# New Product Announcement

MAKE: Ford

TRANSMISSION: 6R80 (2011-On)

PRODUCT TYPE: Bonded Valve Body Plate

**Alto # 183004A**

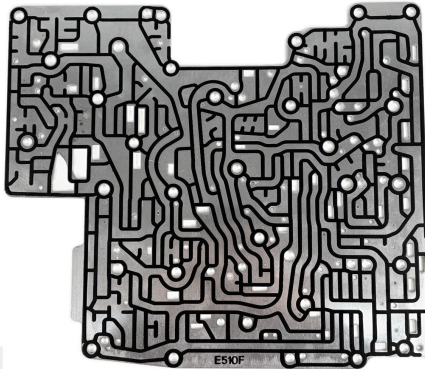
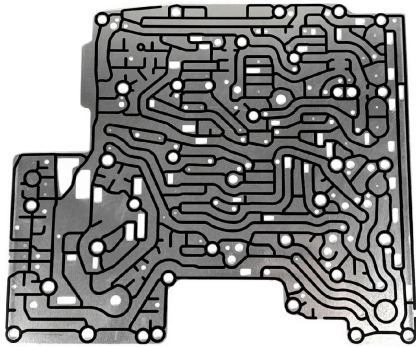
**NOTE\*** The passage hole in the late 2011-On 6R80 plate **Alto # 183004A** has been removed(right), and the D2 Clutch valve in the valve body has been eliminated. On the early 06-08 6R60/75/80 plate **Alto # 183004** this passage hole remains for pump feed pressure to the D2 Clutch(left).
